⑥ National Dam Safety Program. West  
Leechburg Reservoir Dam (NDI-Pa.-452),  
Ohio River Basin, West Penn Run,  
Westmoreland County, Pennsylvania.

**WEST LEECHBURG RESERVOIR DAM**

**PHASE I INSPECTION REPORT  
NATIONAL DAM INSPECTION PROGRAM**

**GAI CONSULTANTS, INC.  
570 BEATTY ROAD  
MONROEVILLE, PENNSYLVANIA 15146  
OCTOBER 1978**

FIGURE 2 CONTRACT NO. 1

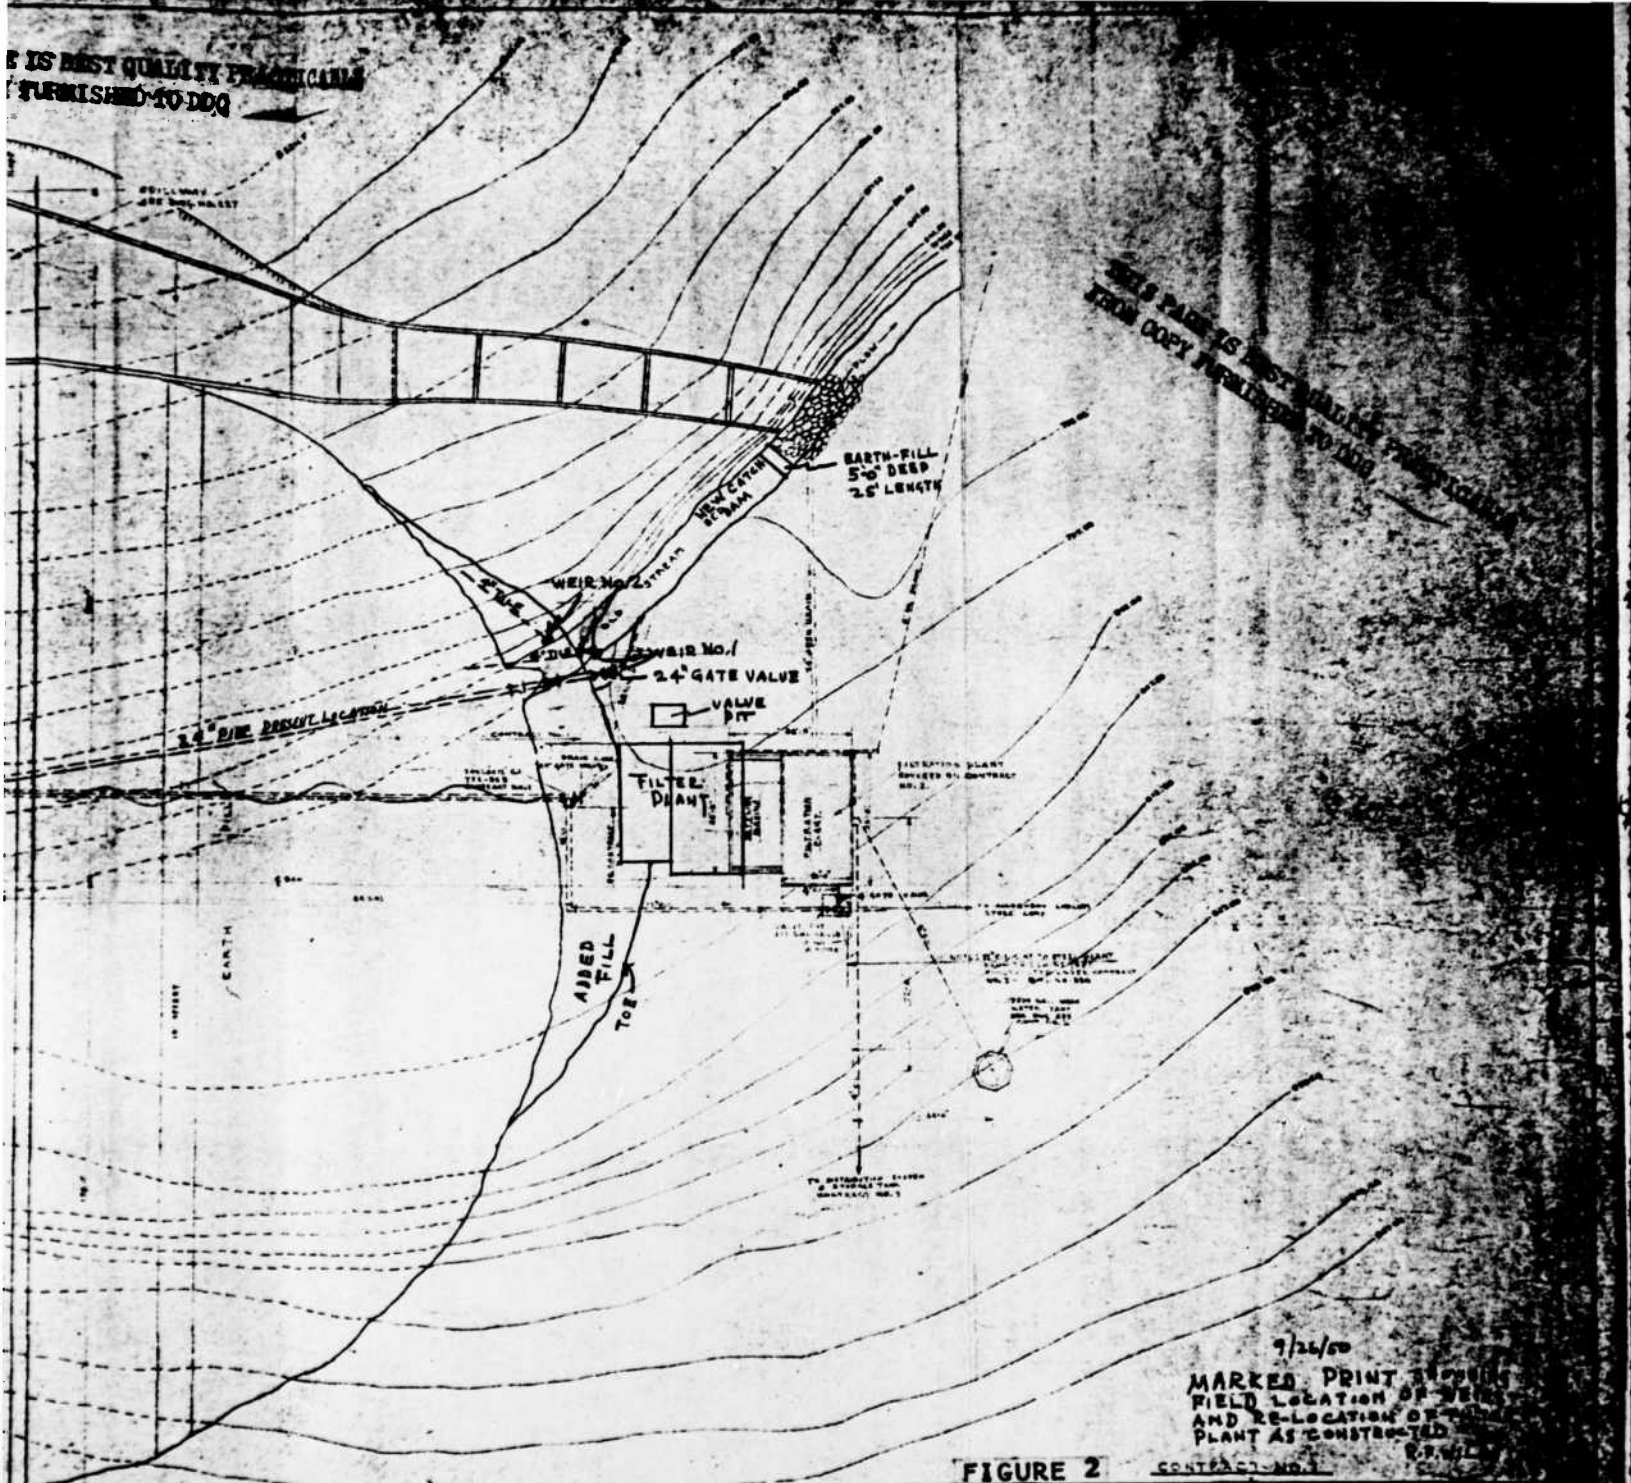
Seepage also discharges through a four-inch tile drain in the old stream channel to the left of the treatment facility. Two tile drains are shown on Figure 2 and are referred to in PennDER reports. The owner claimed that this seepage passes through the left abutment and issues from a spring that was located prior to, or during construction.

Tile drains observed adjacent to the discharge of the blow-off conduit located approximately 25 feet to the left of the treatment facility at the toe of the embankment. The location of the drain lines are shown on design drawings (see Figure 2, Appendix F).

CONTRACT No 1 **FIGURE 4**

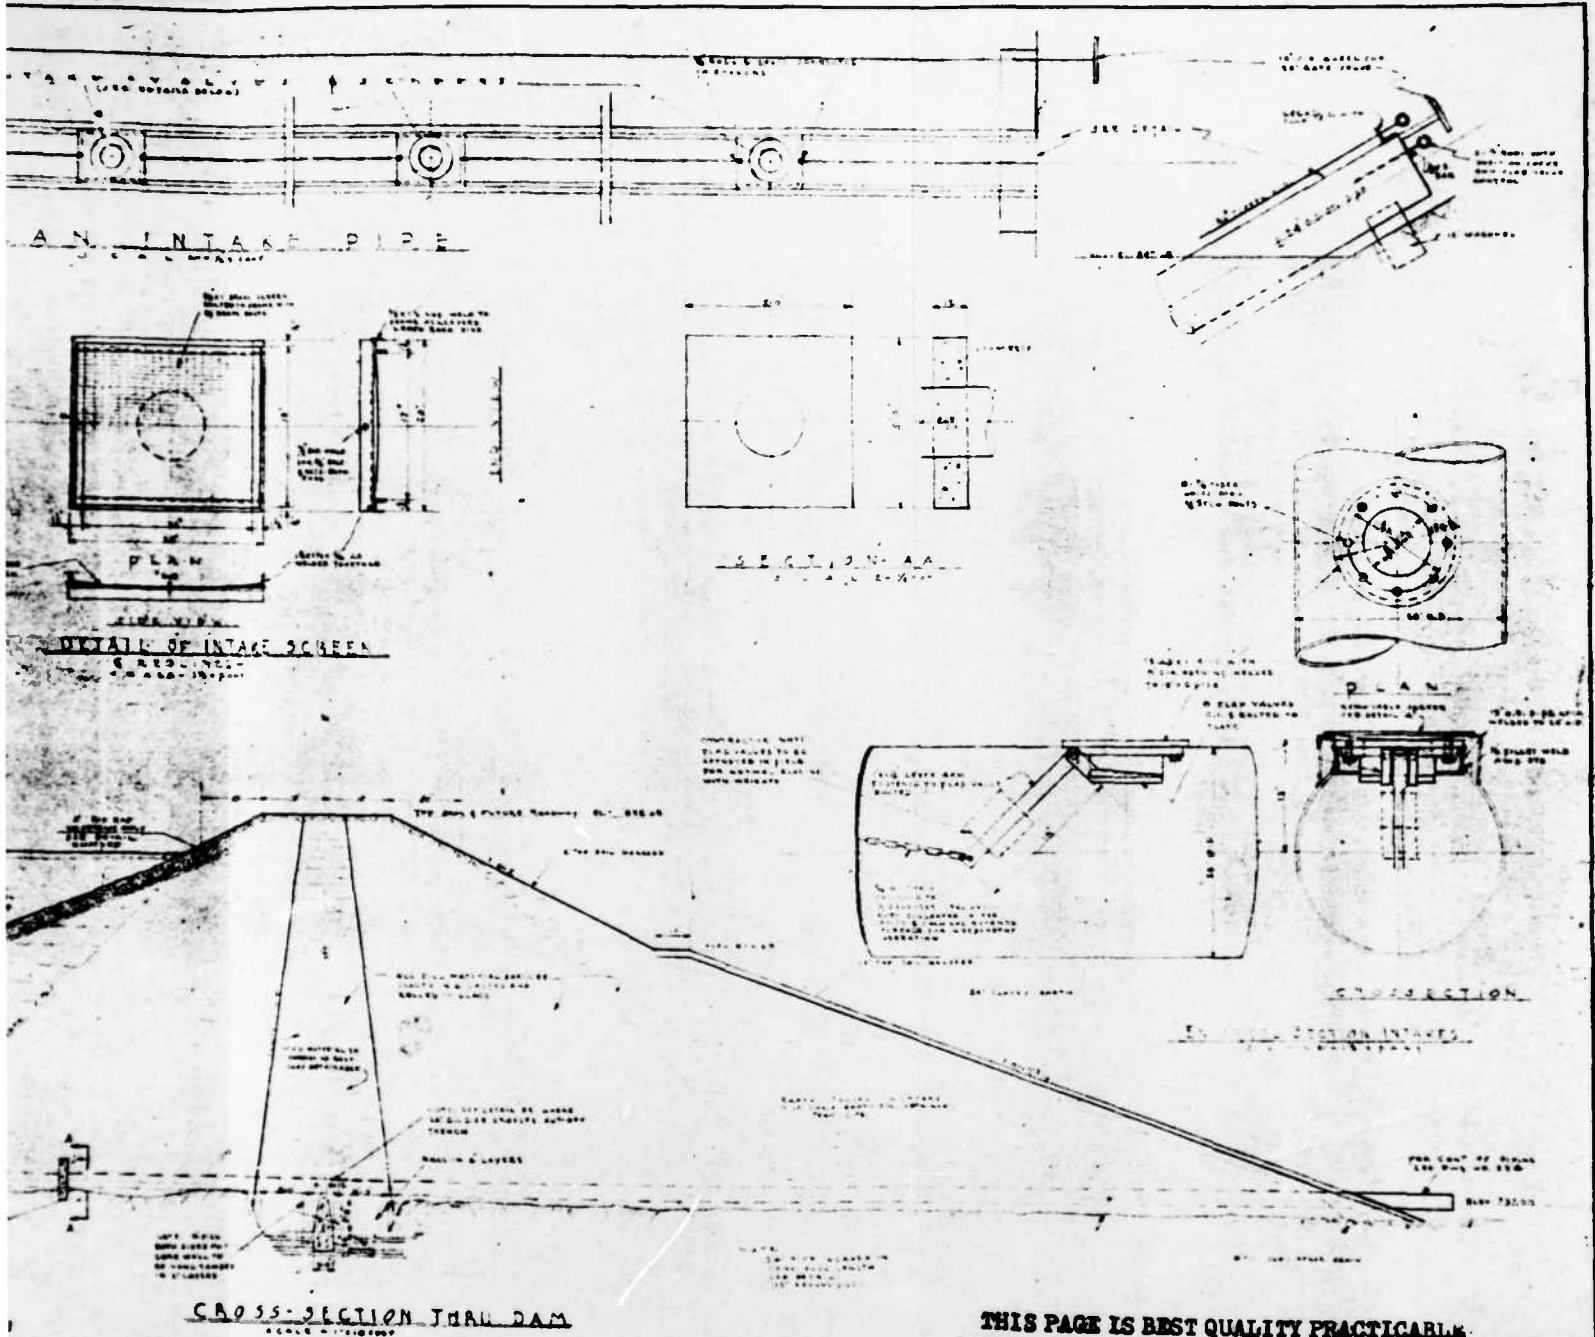
the authority to decant water from five (5) elevations within the reservoir. Reportedly, the gates are corroded open and cannot be closed. Because of this condition, there is no way to regulate flow on the inlet end of the outlet works.

The outlet works at the facility consist of a tee connection on a 24-inch cast iron pipe, encased in concrete beneath the embankment (see Figure 4). The straight section of the tee is gated at the inlet end and rests on the bottom of the reservoir acting as a blow-off. The 90°-section of the tee is connected to a riser pipe containing five gated portal openings at different elevations within the reservoir. This riser pipe protrudes from the reservoir upstream of the spillway along the left bank of the reservoir (see Photographs 1, 4, and 8). Controls for both the gate valve on the blow-off pipe and slide gates on the riser pipe, were operated from this point. According to water company personnel, none of these controls are now functional and all riser gates are thought to be open.

c. Modify or repair the outlet system so as to provide a method for controlling discharge at the inlet end of the 24-inch diameter outlet pipe.
